Correction to the RTS state diagram

Adee Ran, Cisco

RTS state diagram (one instance per interface)

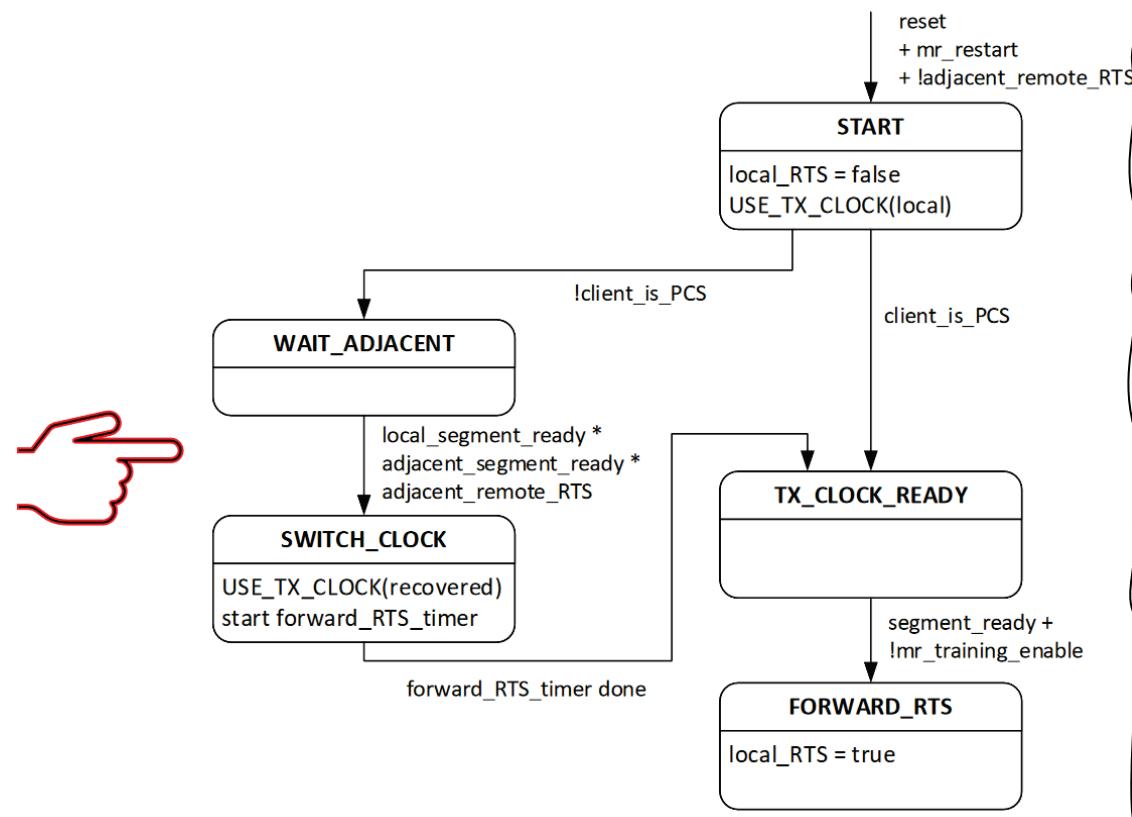
- The RTS state diagram is on slide 7 of the segment-by-segment training proposal,
[ran 3dj 05a 2403](#)
(adopted by motion #13, March 2024).
- It defines the process of asserting RTS by a device (PMA interface), including clock switching.
- ... and it has a problem in the “pointed” transition.

- The condition for the pointed transition includes the variable **segment_ready**.
 - The purpose is to ensure that clock switching is not done while the partner is training.
- In the case where training is not enabled/available on an interface, RTS is communicated by unsquelching the transmitter.
 - In this case, unsquelching should be conditional only on the RTS on the adjacent segment.
 - Making it conditional on **segment_ready** would cause a deadlock.

The RTS state diagram should be made consistent with this logic.

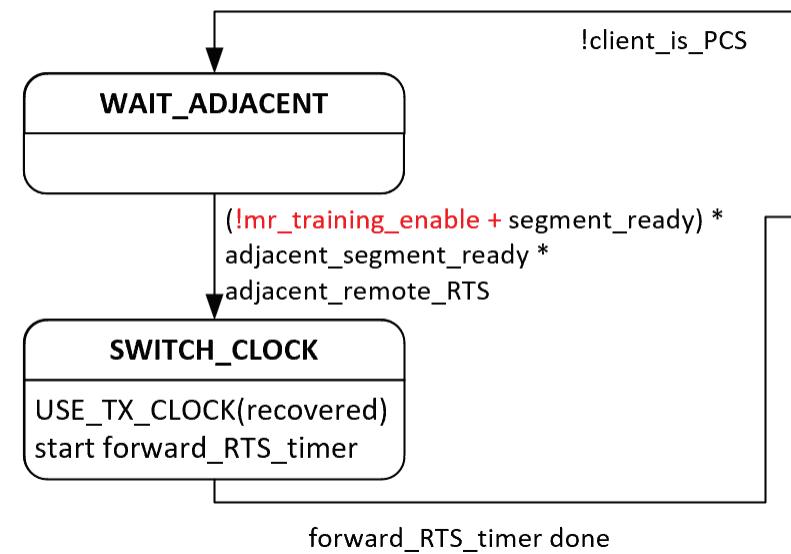
- The condition for this transition should include **segment_ready** only when training is enabled.
- When training is disabled, the clock switching process is conditional only on **adjacent_segment_ready** AND **adjacent_RTS**.
 - This means all previous segments are ready to send data.

- Change the state diagram as shown on slide 4.
- Add an editor's note in D1.0 that the change from the adopted baseline is based on this presentation.
